# Access Compliance Report

## Public Rights-of-Way

### (Curb Ramps)

Intersection ID: 2789	Main Street: MARSHBANK_LN	Cross Street: RIDGEFIELD_DR	Location: SW
ADA ID: B0CC78015E7B	Ramp Type: Perp	Initial Pass/Fail: Fail	Overall Compliance: No
Severity Score: 58.75			
Codes/Mitigation Info/Possible Solution		Field Measurements/Component Compliance

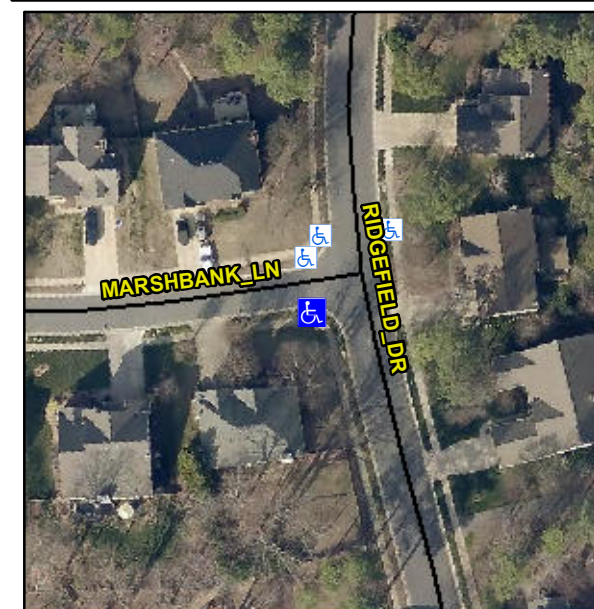
**Not Found, R304.5.1, R304.2.2, R304.5.3**

Compliance	Description	Data	Compliance	Description	Data
N/A	Ramp Length (in)	48.0	No	Ramp Slope (%)	13.1
No	Ramp Width (in)	38.0	No	Ramp XSlope (%)	7.5
N/A	Flare Type LT	N/A	N/A	Flare Type RT	N/A
N/A	Flare Slope LT (%)	N/A	N/A	Flare Slope RT (%)	N/A
N/A	Flare Traversable LT?	N/A	N/A	Flare Traversable RT?	N/A
N/A	Landing Length (in)	N/A	N/A	DWS Provided?	N/A
N/A	Landing Width (in)	N/A	N/A	DWS Contrast?	N/A
N/A	Landing Slope (%)	N/A	N/A	DWS Length (in)	N/A
N/A	Landing X Slope (%)	N/A	N/A	DWS Full Width?	N/A
N/A	Landing Curb? (Y/N)	N/A	N/A	DWS Offset (in)	N/A
N/A	Shared Landing?	N/A			
N/A	Gutter Ponding?	N/A	N/A	Gutter Slope (%)	N/A
N/A	Gutter Lip Ht (in)	N/A	N/A	Gutter X Slope (%)	N/A
N/A	Painted X Walk1?	No	N/A	Painted X Walk2?	N/A
	X Walk 1 Direction	To N		X Walk 2 Direction	N/A
N/A	X Walk 1 Width (in)	N/A	N/A	X Walk 2 Width (in)	N/A
	X Walk 1 Slope (%)	2.2		X Walk 2 Slope (%)	N/A
	X Walk 1 X Slope (%)	3.6		X Walk 2 X Slope (%)	N/A

**Remove & Replace Entire Ramp.**
